DETERMINATION OF APPLICATION FOR MODIFICATION OF DEVELOPMENT CONSENT

Modification Application No: DA2021/419/2

Address and particulars of title of land on which development to be carried out: 44 Hopetoun Avenue, Vaucluse - Lot 34, Sec 7 in DP 9245.

Description of modification to the development consent: Internal and external modifications to the approved new dwelling.

Diagram 1—Extent of screen planting to a minimum height of 2.5m above ground level (existing) required along the western and northern edges of the proposed swimming pool at the lower ground level as shown in yellow.

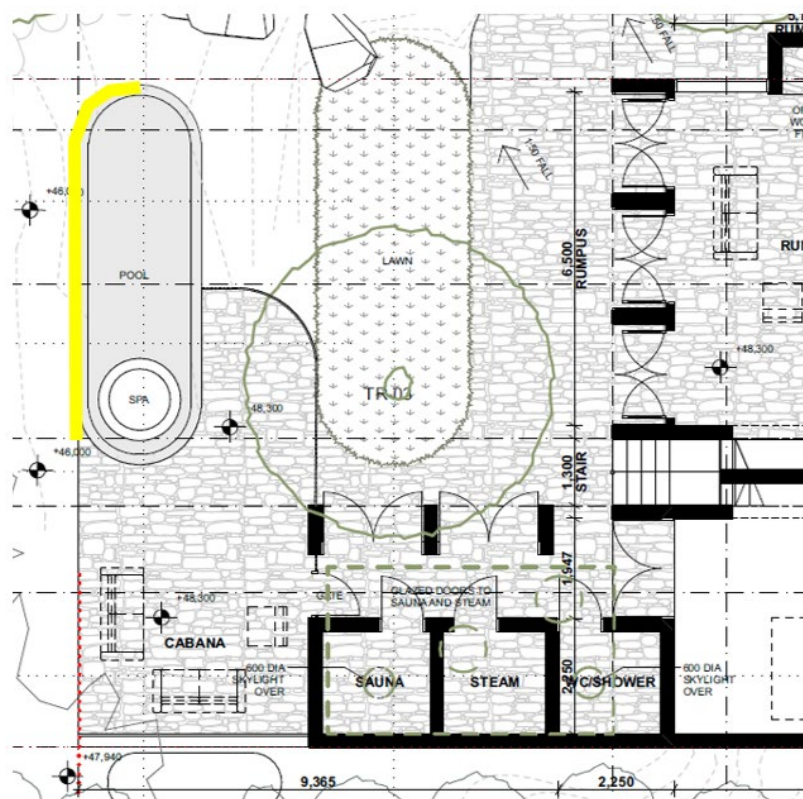
- a) ~~To ensure the swimming pool does not result in an unacceptable presentation to surrounding properties and to comply with the Woollahra Development Control Plan 2015 Part B3.7.4 – Swimming Pools Objective O1, the proposed swimming pool at the lower ground floor must incorporate landscape screening to a~~

minimum height of 2.5m above ground level (existing) along its northern and western edge as shown in Diagram 1 below.
